UNITED STATES PATENT AND TRADEMARK OFFICE

APPLICATION NO.	FILING DATE	FIRST NAMED INVENTOR	ATTORNEY DOCKET NO.	CONFIRMATION NO.
09/960,306	09/24/2001	Donald Richard LaCoy	20272/0688	5354

Office Action Summary

DETAILED ACTION

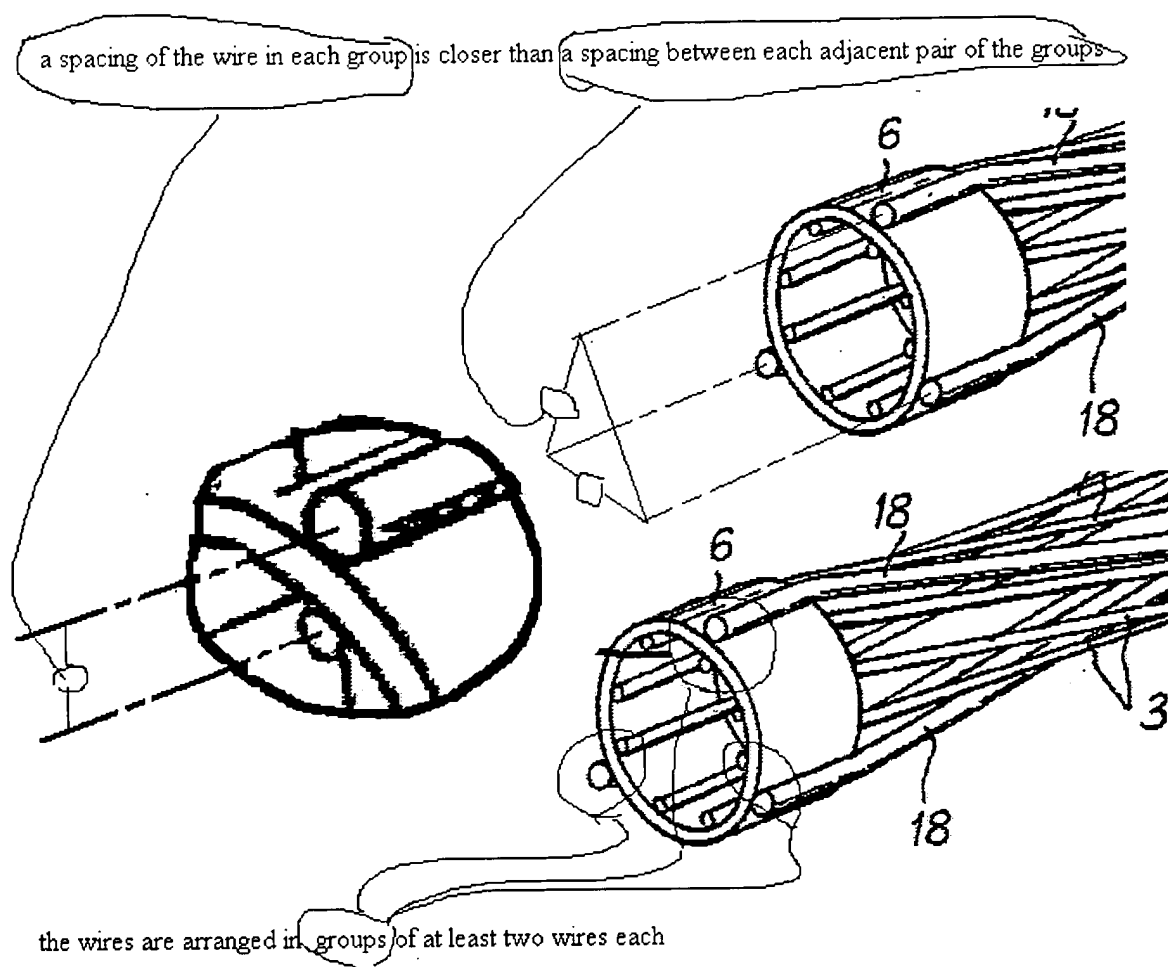
-- In reference to the amended claim language "a spacing between each adjacent pair", the record is not clear if applicant seeks patent protection for a spacing between the circumferential distance or a spacing between a linear distance between the center axis. For purposes of examination, it is assumed that applicant intended to claim the latter (see examiner's figure).

wherein the wires are arranged in groups of at least two wires each (see examiner's detail), and

wherein a spacing of the wire in each group is closer than a spacing between each adjacent pair of the groups (see examiner's figure), and

a third pair of resilient contact wires extending along the socket at an angle to the axis; the third pair of wires being spaced around the socket from the first and second pair (see examiner's detail) and being attached with the first and second support member at opposite ends such that

wherein a spacing between adjacent wires in each of the first and second pairs of wires is less than a spacing between each of the three pairs of wires (see examiner's figure), and

-- In reference to claims 3 and 11, the socket includes three groups of two wires each (see examiner's figure) .
